COWI

MEMO

TITLE	**Suðuroy tunnel - cost estimation of different alignments. 3rd part review**
DATE	20. October 2025
TO	Teitur Samuelsson, Suduroyartunnilin p/f
COPY	Einar Brimnes, Ráð
FROM	Matthías Loftsson, geological engineer, Valgeir Kjartansson, civil engineer, Cowi
PROJECT NO	A294605

Figure 2. Assumed progress of excavation for alternative 1A [Alternative traseer for Suðuroyar tunnilin, Norconsult sept 2025]

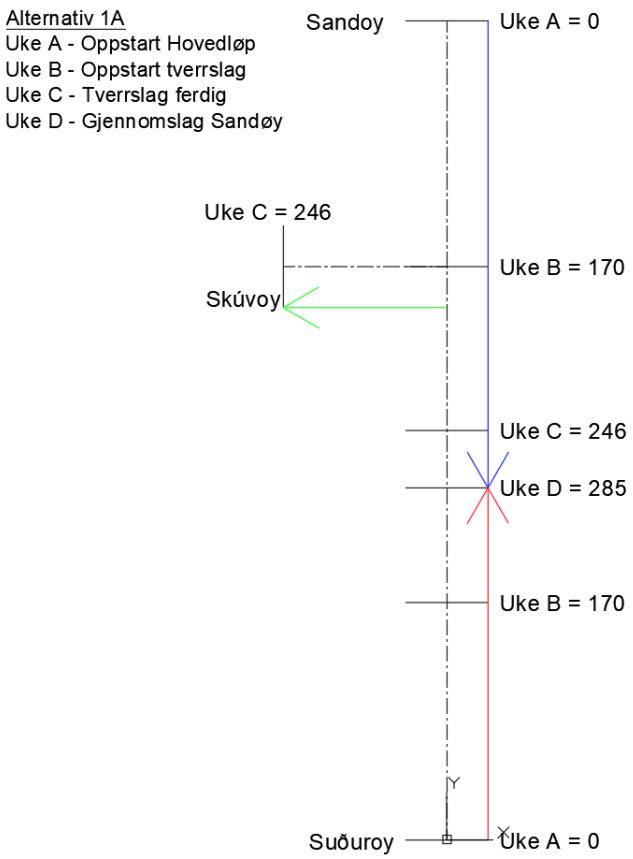
- For all the alternatives, 2 years are assumed for design and tendering. This is considered within acceptable time frame => OK
- Alternative 1A: progress of excavation has been assumed as per figure 2, 285 weeks for excavation which is about 85 m/week (Tunnel to Skuvoy included). Based on experience from Eysturoy and Sandoy tunnels about 80 m/week, total for two faces, more realistic. If assumed alternating drift of excavation for 1550 m (up the Skuvoy tunnel and towards Suðuroy from the cross point), advance will only be 60 to 70 m/week for 3100 m (2 x 1550 m) of the main tunnel and if assuming 80 m/week for the rest, total then about 293 weeks. Having in mind that progress of excavation will reduce with increased distance from portal to face. => Increase excavation time to 5,7 years.

After breakthrough work is estimated 2,6 years (31 month) which is considered which is considered accomplishable. => OK

⇨ Increase total estimated time to 10,4 years.

Figure 3. Assumed progress of excavation for alternative 1B [Alternative traseer for Suðuroyar tunnilin, Norconsult sept 2025]

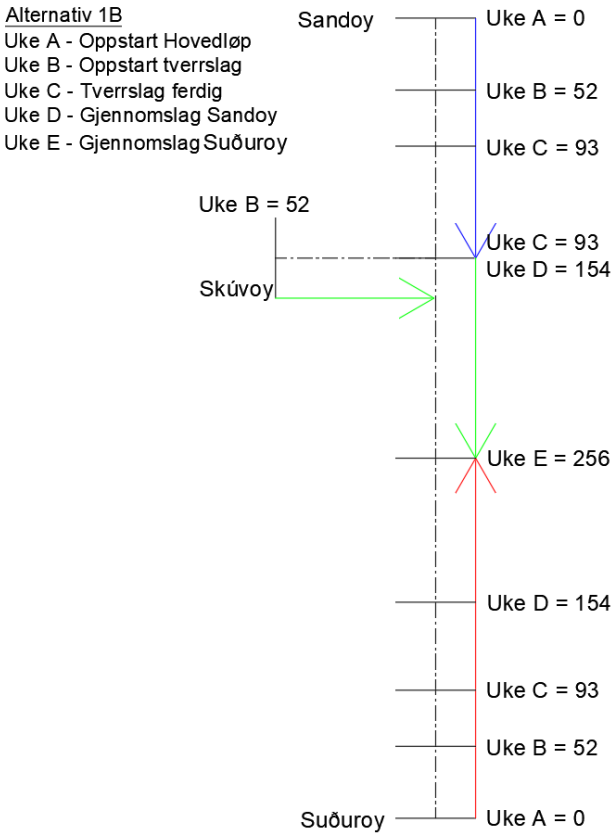
› Alternative 1B: Progress of excavation is estimated 256 weeks, figure 3, starting in week 1 on both ends Sandoy and Suðuroy and with the 3rd rig staring one year later in Skuvoy. Rig from Skuvoy operating in 41 weeks down the Skuvoy tunnel which accounts to about 35 m/week and then additional 60 weeks for remaining of the tunnel. Estimated 256 weeks (4,9 years) for excavation to breakthrough => OK

For after breakthrough work only 1,8 year is estimated, 10 months less than for alternative 1A. This is debatable as space in the main tunnel is the same despite additional access from Skuvoy. It took 19 months to complete interior work for Eysturoy tunnel with 3 portals or about 83% less time than for Sandoy tunnel. If using the same precentage for interior work as was the difference between Eysturoy and Sandoy tunnels, after breakthrough work will take about 2,1 to 2,2 years.

⇨ Increase total estimated time to 9,1 years.

Figure 4. Assumed progress of excavation for alternative 2A [Alternative traseer for Suðuroyar tunnilin, Norconsult sept 2025]

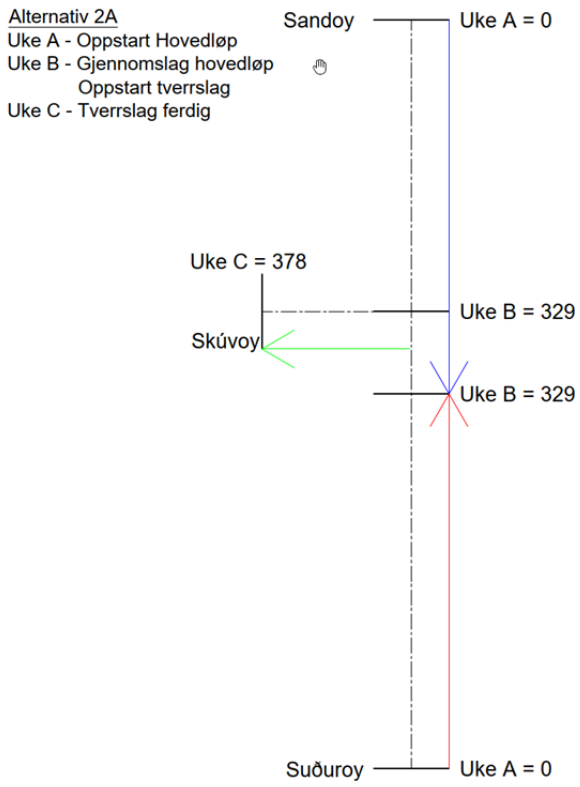
› Alternative 2A: progress of excavation has been assumed as per figure 4, 378 weeks for excavation which is about 74 m/week (Tunnel to Skuvoy included). Based on experience from Eysturoy and Sandoy tunnels about 80 m/week, total for two faces is realistic and if progress of excavation up the Skuvoy tunnel is 35 m/week, total of 378 weeks is considered accepable. If, however, assumed alternating drift of excavation for 1870 m (up the Skuvoy tunnel and towards Suðuroy from the cross point), advance will only be 60 to 70 m/week for about 3740 m (2 x 1870 m) of the main tunnel and if assuming 80 m/week for the rest, total then about 339 weeks. Having in mind that progress of excavation will reduce with increased distance from portal to face. => Excavation should be estimated between 6,5 to 7,3 years. => Use 6,9 years instead of 7,3

For after breakthrough work only 1,7 year is estimated, 11 months less than for alternative 1A. This must be an error. Interior work for longer tunnel takes longer time. Increase estimated time from 1,7 to 3 years.

⇨ Increase total estimated time to 11,9 years.

Figure 4. Assumed progress of excavation for alternative 2B [Alternative traseer for Suðuroyar tunnilin, Norconsult sept 2025]

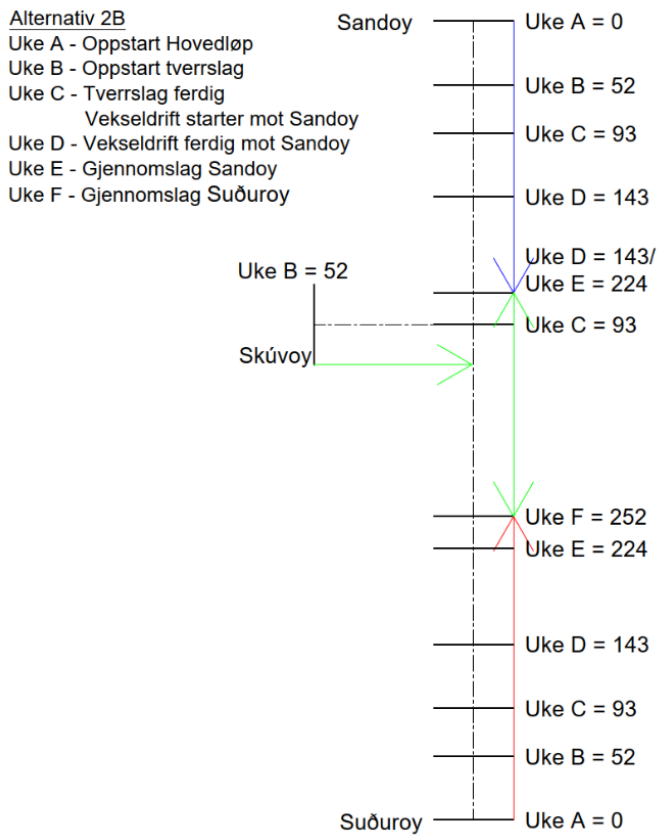
› Alternative 2B: Progress of excavation is estimated 252 weeks, starting in week 1 on both ends Sandoy and Suðuroy and with the 3rd rig staring one year later in Skuvoy. Rig from Skuvoy operating in 41 weeks down the Skuvoy tunnel which accounts to about xx m/week and then additional 60 weeks for remaining of the tunnel in on alternating faces. Estimated 252 weeks (4,8 years) for excavation to breakthrough. This is less time than for alternative 1B which cannot be correct. If assuming 60 m per week for alternating face driving and 40 m/week for single face driving total time would be close to 284 weeks => Increase estimated excavation time to 5,5 years.

For after breakthrough work only 2,5 year is estimated => OK

⇨ Increase total estimated time to 10 years.
